# AOD-1 ALEWIFE

PLANNING BOARD MEETING  
CITY OF CAMBRIDGE

# PURPOSE OF PETITION

## INCORPORATE **ALEWIFE DISTRICT PLAN** RECOMMENDATIONS INTO ZONING FOR ALEWIFE OVERLAY DISTRICT 1 (AOD-1)

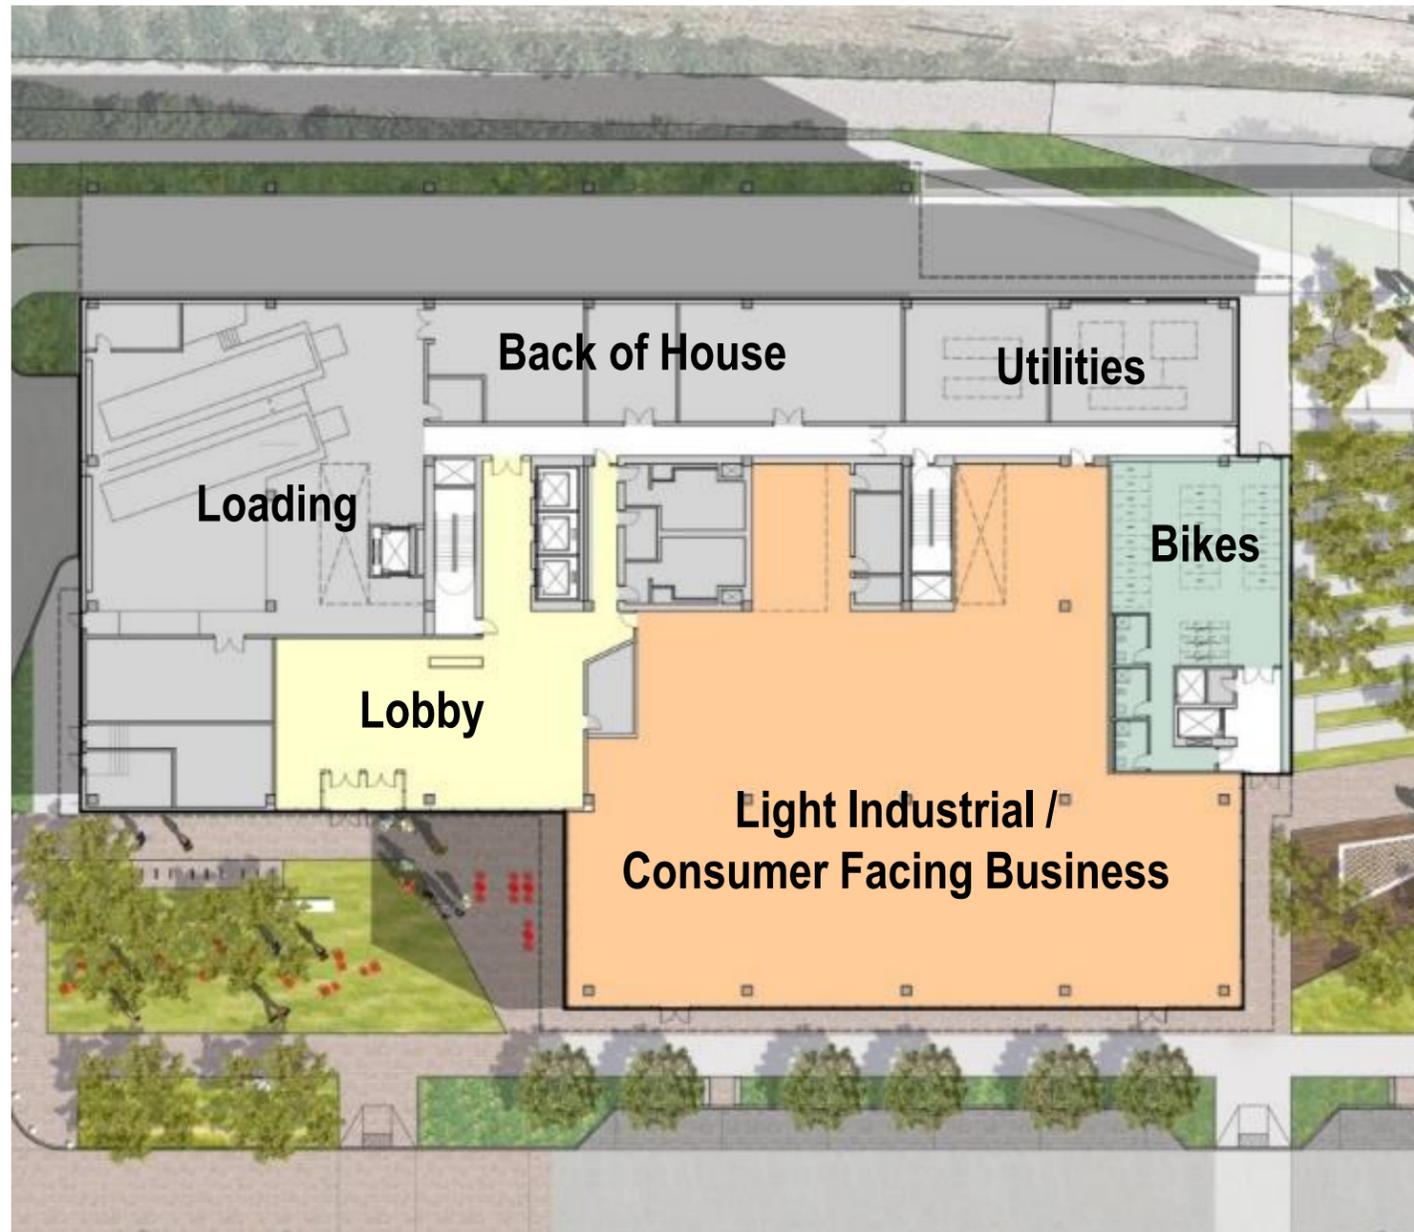
**BOARD COMMENT:** Demonstrate that the Alewife District Plan is addressed comprehensively and that the proposed zoning would fully enable outcomes envisioned by that plan.

**RESPONSE:** The revised Petition now includes Section 20.95.53 that explicitly requires the Planning Board to make findings that the development proposal is generally in conformance with the Alewife District Plan.

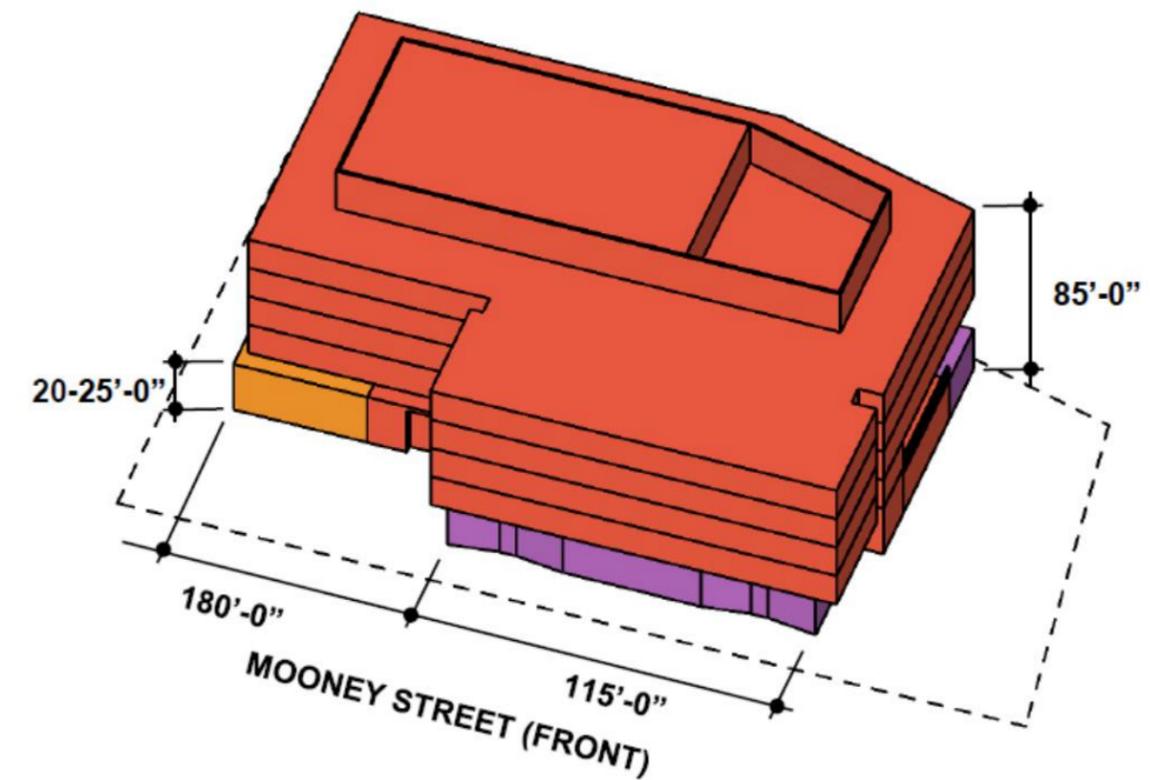
**BOARD COMMENT:** Board members asked the petitioners' representatives to respond to neighborhood concerns about the added height and bulk from mechanical equipment.

**RESPONSE:** Alewife District Plan outlines Urban Form recommendations that include reducing visual bulk of building massing (pg. 115-123). Revised Petition requires that Planning Board make a finding that the building massing is consistent with these recommendations.

# PLANNING BOARD COMMENT / AOD-1 DISTRICT ANALYSIS

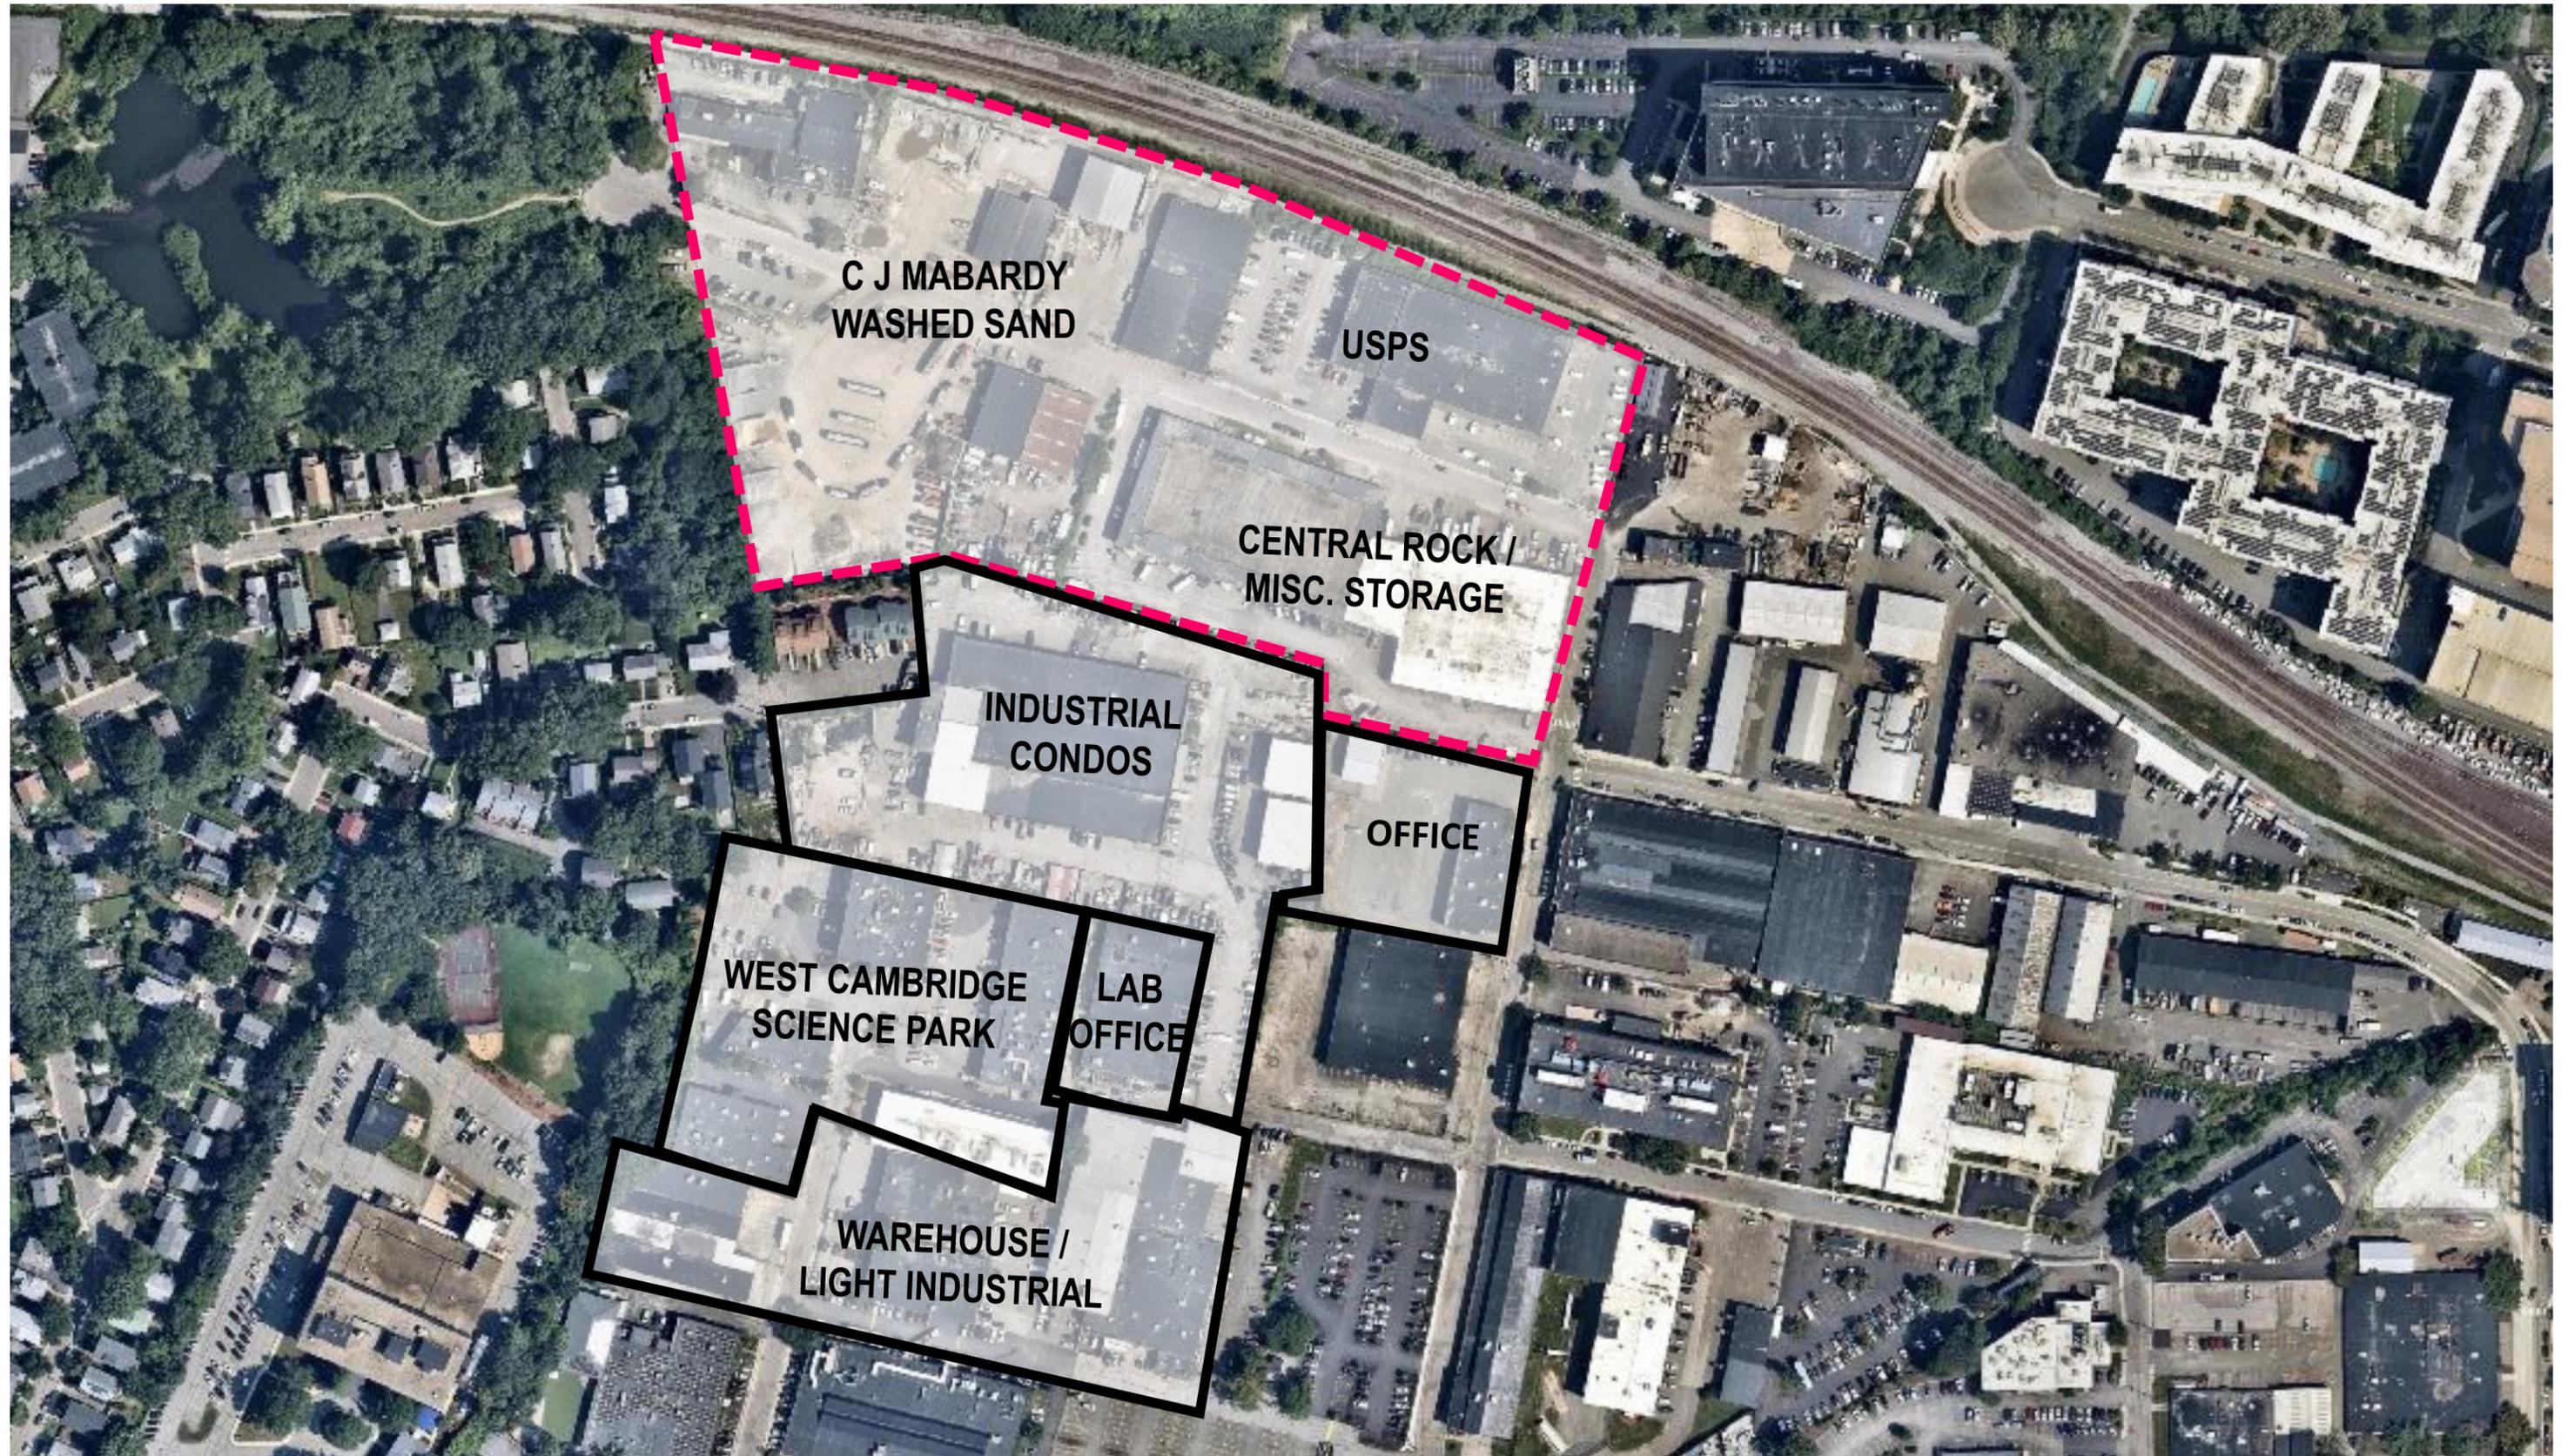
**BOARD COMMENT: Board asked for an assessment of how other properties in the AOD-1 would be affected.**
